## Wards Lake Park Phase 1 & 2 Improvements

City of Lakewood Parks and Recreation

### ADDENDUM NO. 1

November 13, 2024

**L-103.1**

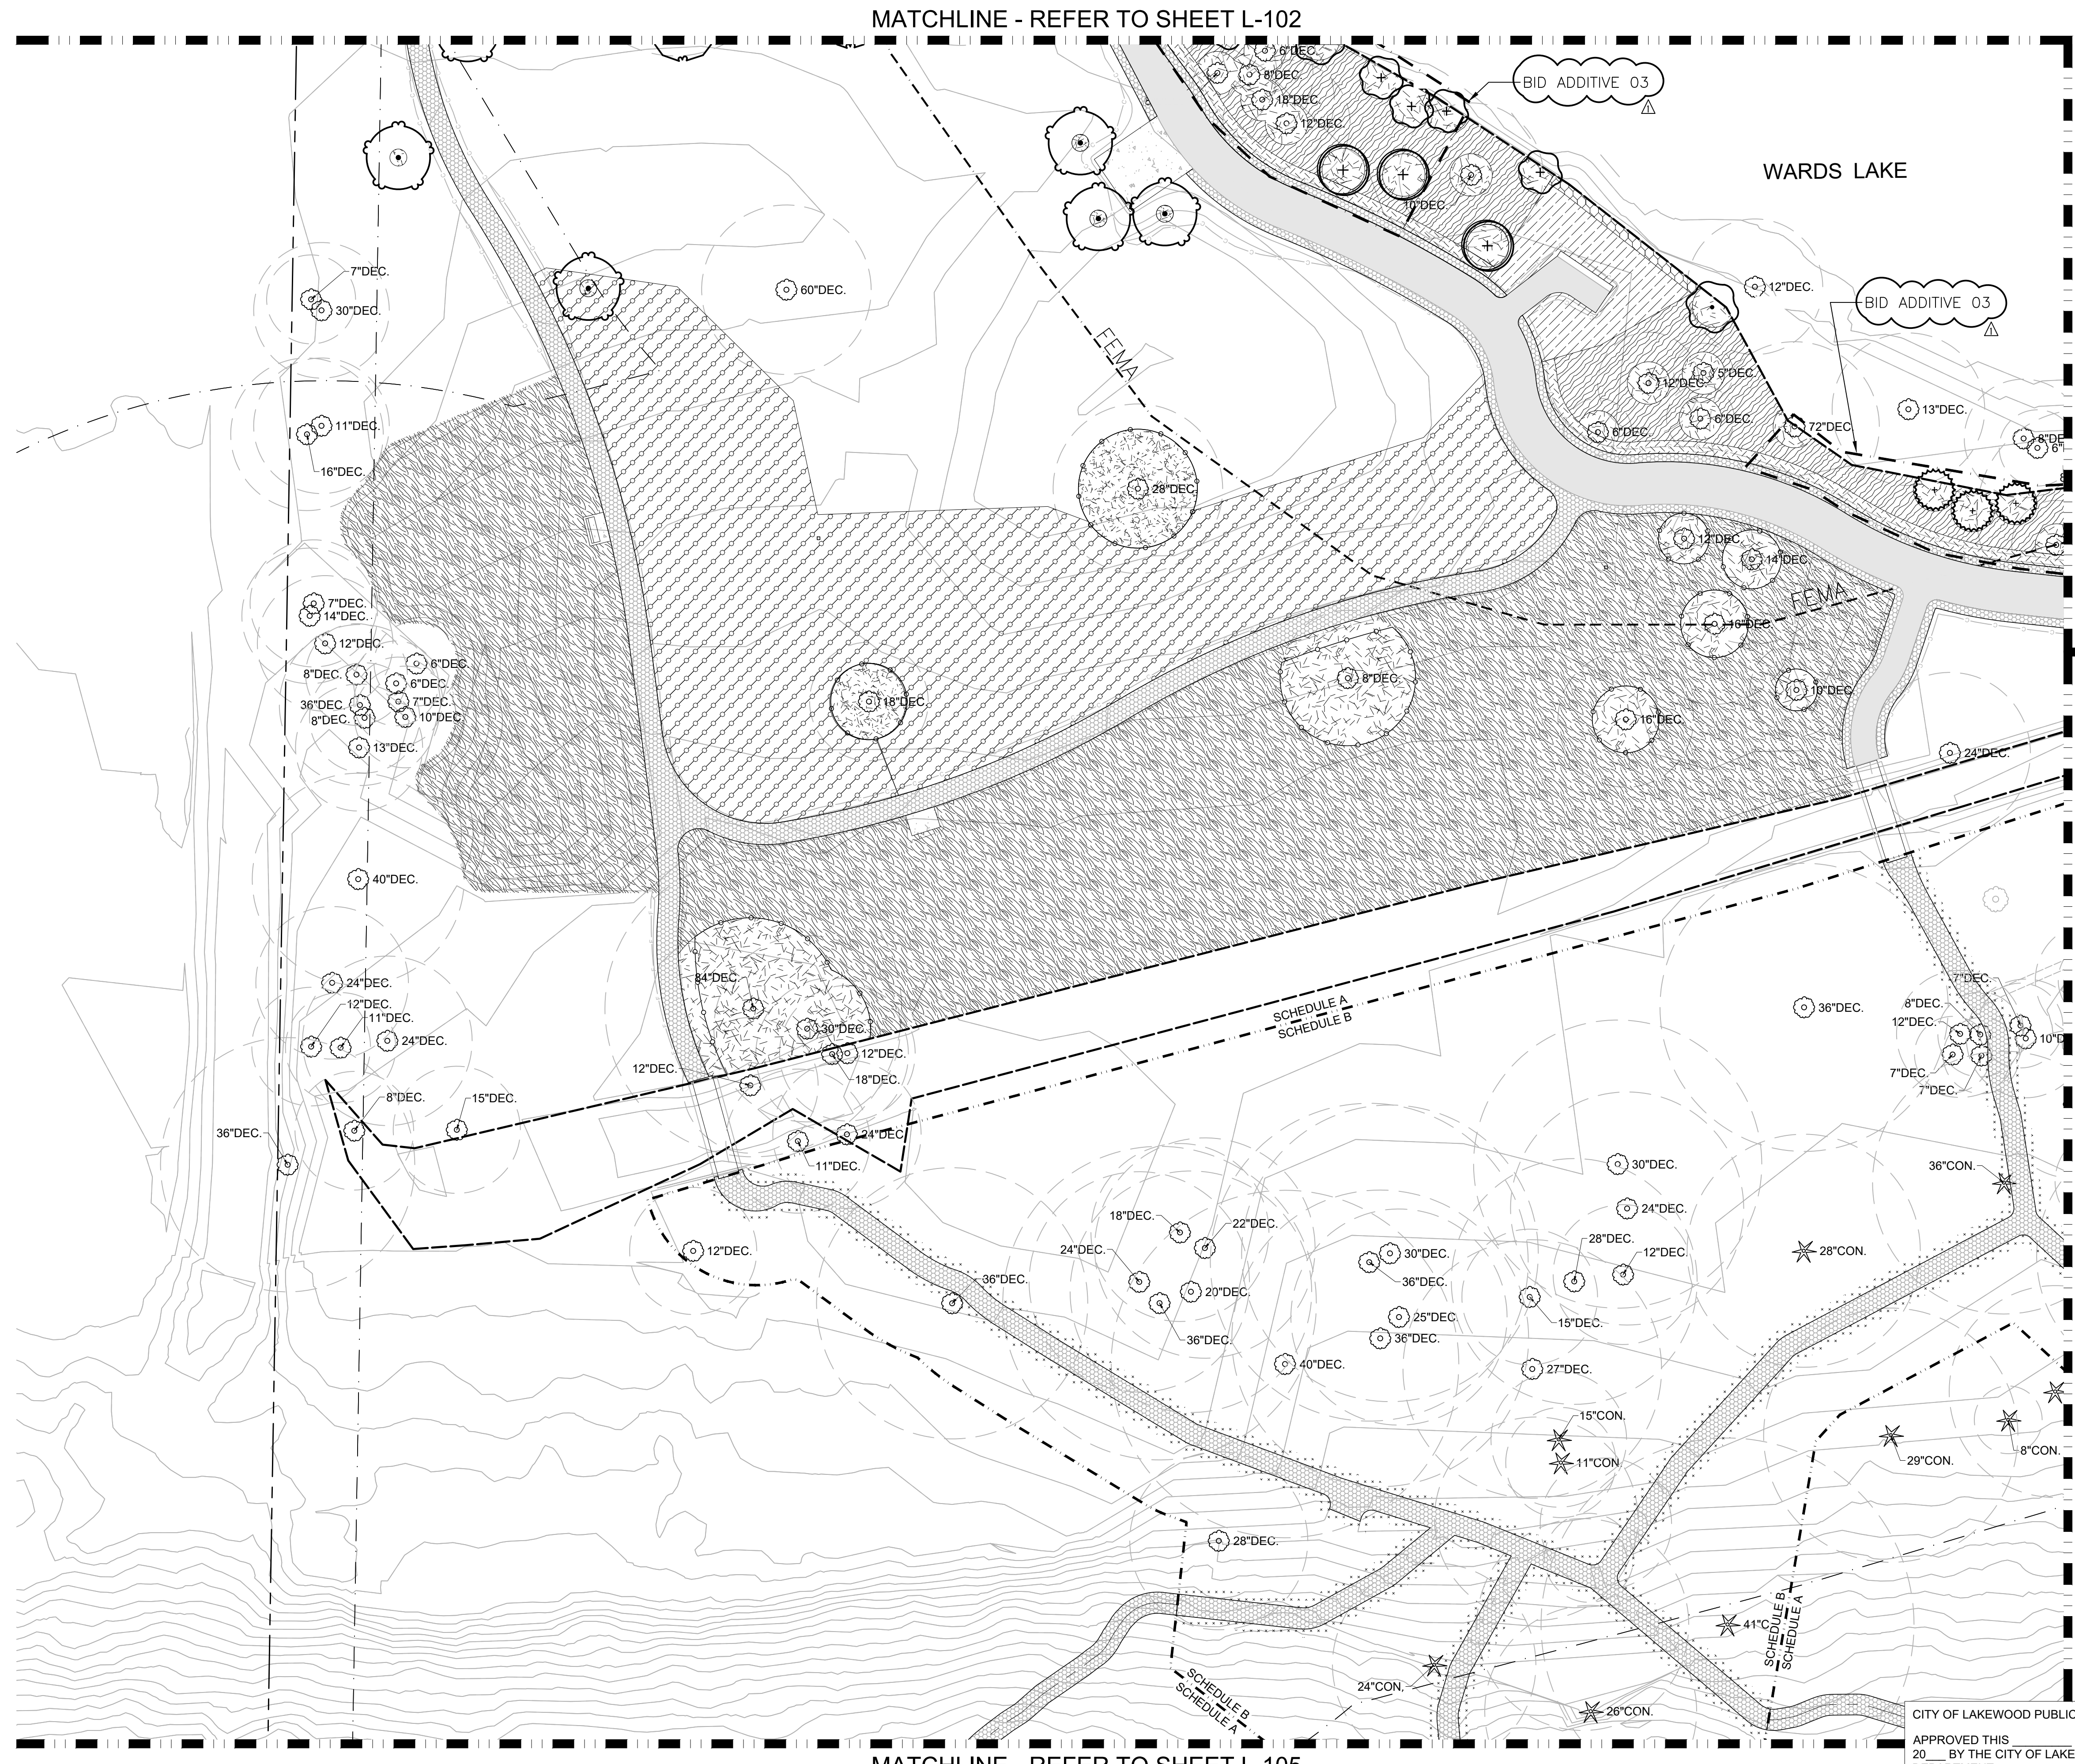
**REVISE** plant symbol in legend.

**L-112**

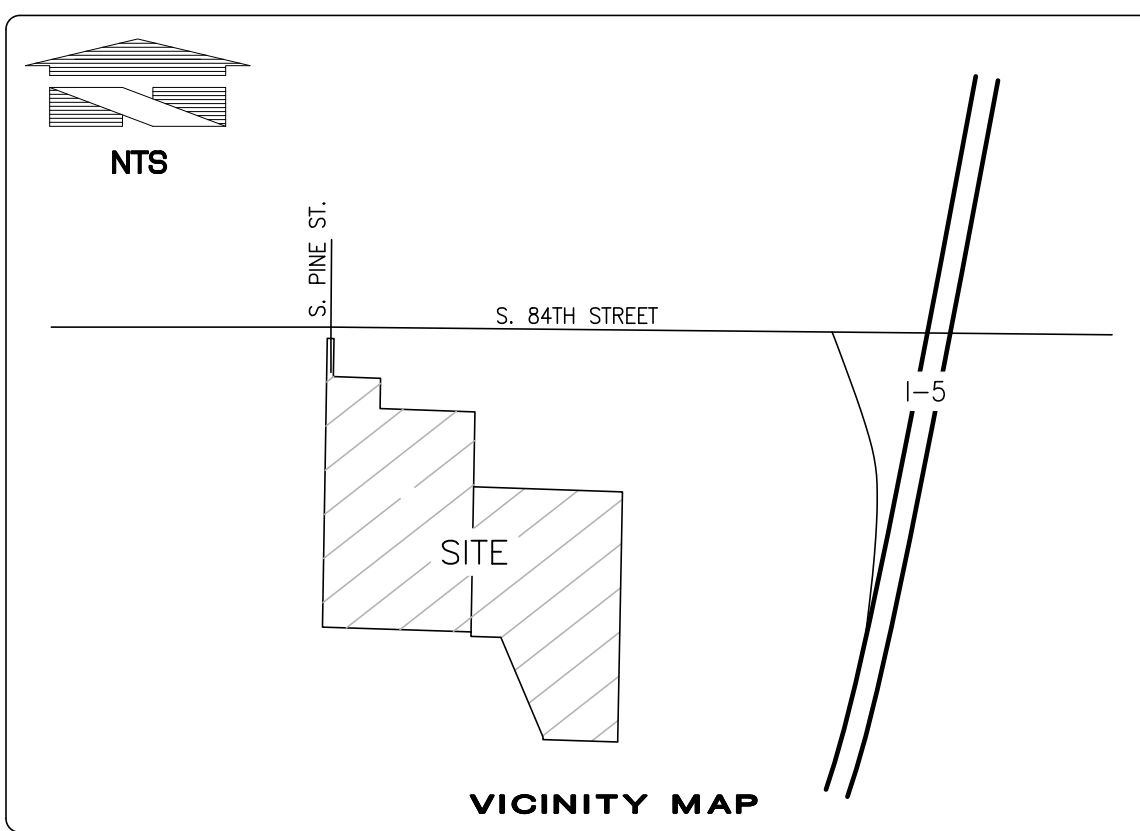
**REVISE** plant symbol in legend.
